## SERVICE BULLETIN

**Bulletin No:** JC-13-22

**Product Type:** STEINER

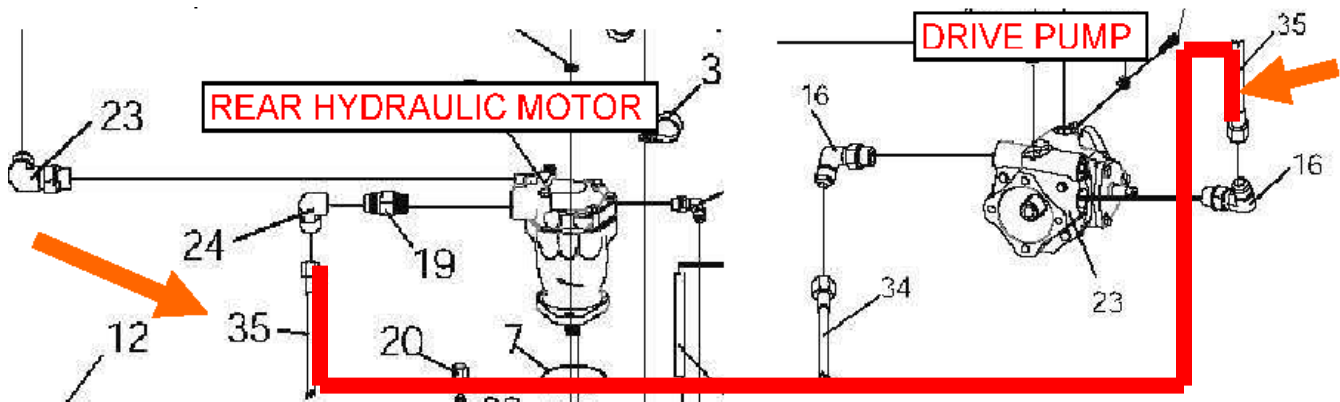
- A. Leaking drive hose
- B. Loose drive shaft = Loss of hydraulic pressures
- C. Pedal dampener working loose

- A. Hose will not hold up to all conditions in which a Steiner tractor may be used
- B. Drive shaft assembly bolts and set screws are not tight enough
- C. Dampener has potential to slide off the spacer

1. Remove hose 4166843-02 and replace it with hose 4169240-01. Tie something on to the hose and pull it through the tractor as you remove the old hose. Then use that to help pull and route the new hose into the tractor.
2. It should be easier to do this repair when you have the radiator out for drive shaft repair.

1. Drain and remove the radiator.
2. Release the belt tension going to hydraulic pump.
3. Remove the coupler set screws, retain for reuse. Remove the drive shaft assembly from the pump pulley and engine pulley. (Mark the shaft assembly: engine side and pump side) Engine side bolts are metric.

#### **Drive shafts: KOHLER**

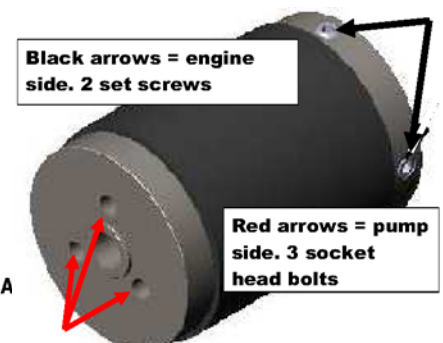
1. Remove the 4 engine mounting bolts
2. Loosen the 2 set screws in the coupler on the engine side

3. Lift and move the engine forward separating the drive shaft or pulling the coupler off the engine crankshaft.
4. Remove the coupler from the pump pulley.

6. Reassemble the drive shaft
  - Install the pump coupler onto the pump pulley. Torque the 3 bolts to 22 ft.-lbs.
  - Slide the engine into place, inserting both couplers into the rubber insert and bolt it tight.

- Slide the engine coupler until there is approximately 1/16" gap between the rubber insert and one coupler. This allows crankshaft endplay.
  - Apply removable lock-tight on the set screw threads and in the threads of the coupler on the engine side. Double set both set screws to 12 ft.-lbs.
